Office Action Summary	Application No.	Applicant(s)	
	09/145,982	HASE, TOMOHARU	
	Examiner	Art Unit	
	Hung Henry V Nguyen	2851

DETAILED ACTION

Fig.7 of Tanimoto

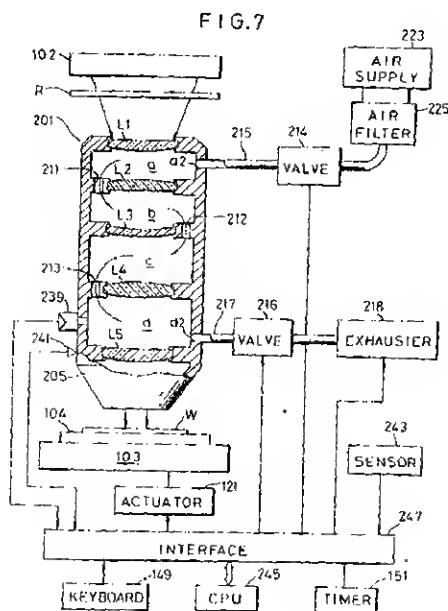
With respect to claims 36-41, 44-46, 57-62 and 65-67, Tanimoto et al (fig.7) discloses an exposure apparatus comprising all basic features of the instant claims including: an optical system (201) having at least one optical element (L1-L5) and including a supporting portion (205) for supporting at least one optical element and having a plurality of apertures (211-213) through which a gas can flow; an illumination optical system (102) for illuminating a reticle (R) and a gas supply (223); the optical system comprises a plurality of spaces (a-d) where the apertures of the two adjacent two lenses are placed "at rotational positions, about an optical axis of the optical system, with angle other than zero degree and 180 degrees"/ or "the a straight line connecting apertures of the adjacent two separating portions is not parallel to any of the optical axes /or is not contain in any of planes including optical axes of the optical elements of the adjacent two separating portion (as clearly illustrated from fig.7).

8. Applicants' amendments filed September 2, 2003 have been entered. Applicant's arguments with respect to prior art rejection have been carefully reviewed but they are not found persuasive. Based on figure 7 of Tanimoto, Applicant argues that while Tanimoto teaches air holes (for example: 211, 212) between adjacent optical element spaces are located 180 degrees apart, claims 37 and 57 of the present applicant, call for "with angles other than zero degree and 180 degrees"; the Examiner respectfully disagrees with the applicant. Firstly, the amended claims 36 and 57 are rejected under 35 U.S.C. first and second paragraphs as set forth above. Secondly, the Applicant can not rely on the drawing of Tanimoto to support his/her position since the drawings in a patent need not be drawn to scale. Unless otherwise stated, there is no evidence, or any statements in reference of Tanimoto, other than applicant's arguments, which suggest that apertures (211, 212) are disposed at 180 degrees difference. Also, it is the Examiner's position that the difference would be met by manufacturing tolerance and/or defect. Would having a very small angular difference, such as 0.000001 degrees between the air hole 212 and the air hole 213, achieve the claimed results? Yes, since such angular difference would be very common in manufacturing. Finally, Applicant argues that a straight line between air holes 211 and 212 and a straight line between air holes 212 and 213 are not parallel to the optical axis of the optical system, these straight lines therefore intersect the optical axis of lens L2; the Examiner disagrees with the Applicant since this is not quite true. One having ordinary skill in the art would recognize that the straight lines between air holes 212 and 213 and the straight line between hole 211 and 212 do intersect with a plane that contains the optical axis of the optical

system but these straight lines may not intersect with the optical axis of the optical elements.

Therefore, Tanimoto meets all of the limitations of the instant claims.

Fig.7 of present application

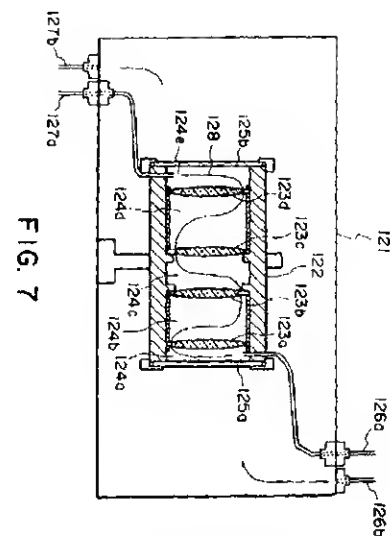
As to claims 36 and 57, the specification of the disclosure lacks adequate support for the claimed provision of "wherein apertures of the adjacent...with an angle other than zero degree and 180 degrees". Applicant is reminded that when claimed elements that are not fully discussed in detail, this falls under 112, first paragraph, applicant's disclosure is lacking in this aspect. The remotest relevancy to the claimed subject matter may be figure 7 and in the statement of "a straight line connecting the passages 32 of adjacent lens supports 31 is out of

parallel to an optical axis of the lens 30" (see page 14, line 14 to page 15, line 6). However, it is the Examiner's position that this statement and figure 7 (or figure 2) fail in any manner to teach the claimed limitation of apertures of adjacent separating portions being rotated from one another at other than zero or 180 degrees. If the Applicant does not agree with the Examiner, the Examiner respectfully submits that Applicant points out clearly supporting evidences that the instant specification supports the subject matter which applicant regards as the invention. Comparing figure 7 of instant disclosure and figure 7 of Tanimoto et al' 4,690,528, the Examiner fails to find any differences.
